Office Action Summary

10/757,949

LEHMANN, ROLF

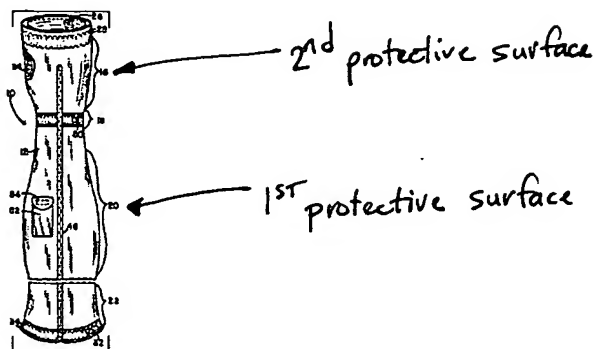
Santa Cruz et al. discloses a glove with a sleeve 10 wherein the sleeve has a first protective surface 20 for protecting the lower arm/wrist (see figure below).

With regard to claim 2, the glove is designed with a second protective surface 16 in the form of a salient bracket for the back of the hand.

With regard to claim 3, the second protective surface 16 extends as far as the area of one or both sides of the hands.

With regard to claim 4, the second protective surface 16 extends as far as the area of the finger ends.

With regard to claims 5/1, 5/2 and 5/3, the first 20 and second 16 protective surface is detachably secured to the glove (Col. 3, lines 12-29).

With regard to claims 6/1, 6/2 and 6/3, the first protective surface 20 and the second protective surface 16 has at least one layer consisting of cut-resistant protective material. Any material is inherently cut-resistant only that some are superior to others.

With regard to claims 10/1, 10/2 and 10/3, the first protective surface 20 and the second protective surface 16 is secured to the glove 10 via elements 24, 32 and zipper 46.

With regard to claims 11/1, 11/2 and 11/3, the first protective surface 20 has at least one fixing means 32 for adjustment to the contour of the lower arm.

With regard to claims 12/11/1, 12/11/2 and 12/11/3, the fixing means is an elastic strap 32.

With regard to claims 13/1, 13/2 and 13/3, the width of the first protective surface 20 is such that the lower arm is completely covered by the first protective surface 20 and the length of the first protective surface 20 corresponds to at least half the length of the lower arm.

With regard to claims 14/1, 14/2 and 14/3, the second protective surface 16 corresponds to roughly the surface of the back of the hand.
